Crabtree Lane, Openshaw

Stage 1 Road Safety Audit

Designer's Response

Curtins Ref: 086840-CUR-XX-XX-T-TP-00004

5 AUDIT LOCATION PLAN

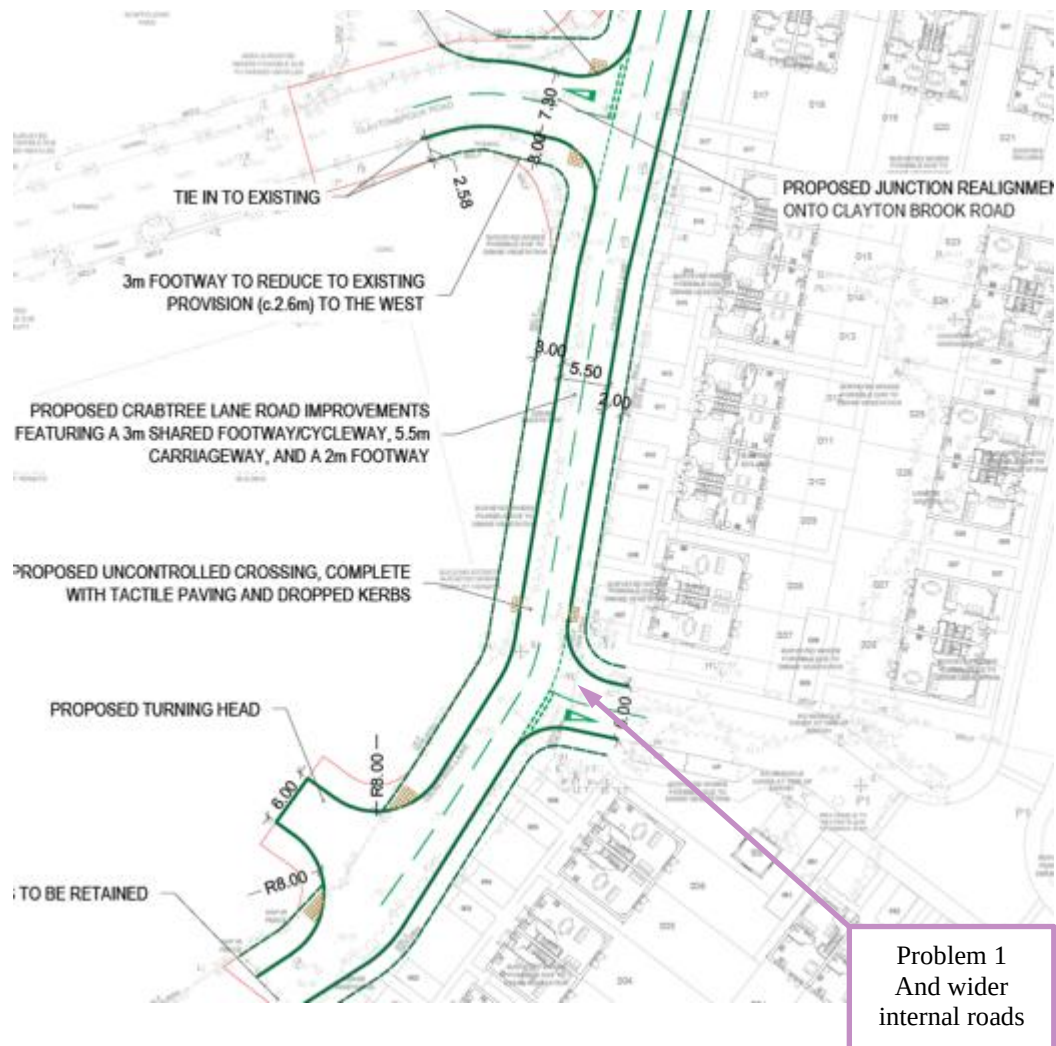
2.3 Problem 1

Location: Wider Development Site and Southern Development Access With Crab Tree Lane

Summary: No pedestrian crossing facilities identified

Appropriate pedestrian facilities in the form of a dropped crossing with associated tactile paving is critical in allowing the safe movement of vulnerable road users particularly the disabled, elderly and young. Lack of these facilities can result in vulnerable users becoming trapped in carriageway with a resulting increased risk of collision with passing vehicles. There is also the potential for slips / trips and falls to increase without the provision of appropriate crossings

Recommendation

Appropriate crossing facilities should be provided on appropriate desire lines through the area and at junction locations in particular.

- 2.1.1 The only issue raised by the Stage 1 Road Safety Audit was a lack of pedestrian crossing facilities shown on **Drawing 086840-CUR-XX-00-D-TP-75001-P04** across the internal road at the southern junction with Crabtree Lane and throughout the internal roads. The auditor recommended that appropriate crossing facilities should be provided on appropriate desire lines through the area and at junction locations in particular.
- 2.1.2 This recommendation is accepted by the design team and additional crossings would be provided at the detailed design stage.
